STAFF REPORT 05-10-2023 MEETING

APPLICATION NUMBER: 23-8337

ADDRESS: 1346 BROADWAY

SCOPE: REHABILITATE BUILDING

Detail view of the window and façade conditions. Staff photo, April 19, 2023.

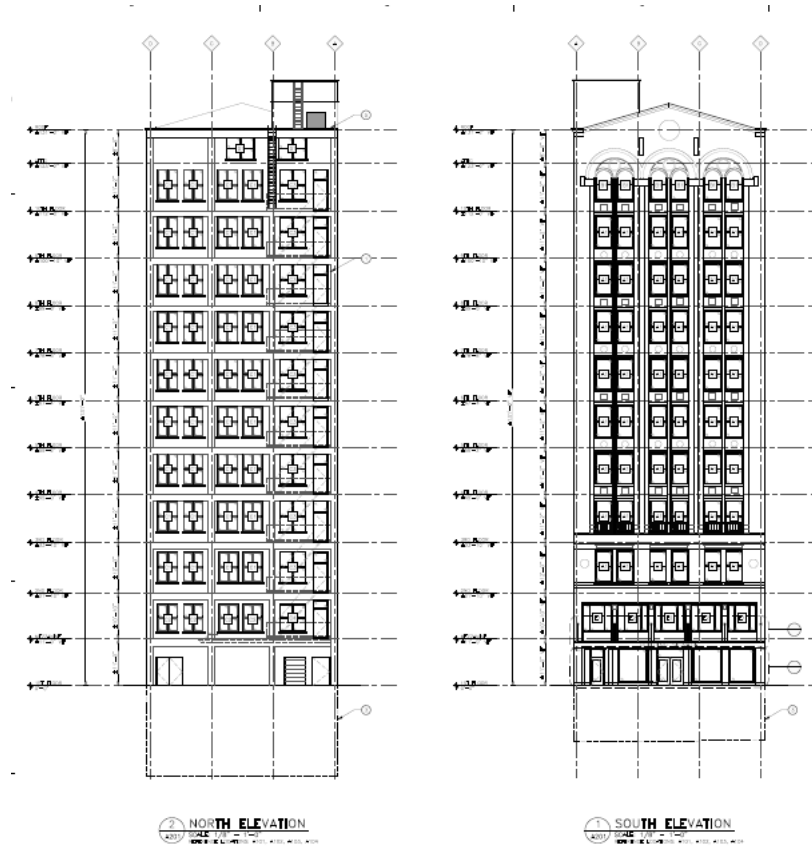
- The applicant states that the existing windows above the mezzanine level are steel and have rusted into a ruined condition that precludes effective and feasible restoration. A selection of photographs, and a report provided by Blackberry Windows, supports this contention. Staff agrees with this professional assessment.

- For the proposed replacement windows, reviewed with respect to the NPS guidance given above, staff finds that the proposed replacement windows effectively reproduce the design and visual qualities of the original windows. New windows of the same historic material (steel) are neither feasible nor commonly available. The proposed windows, from Quaker’s commercial product line, reproduce the design, operation, and visual qualities of the historic prototypes, and are recessed properly into the façade, preserving historic shadow lines. Staff assesses that the proposed aluminum windows therefore satisfy Standard 6.
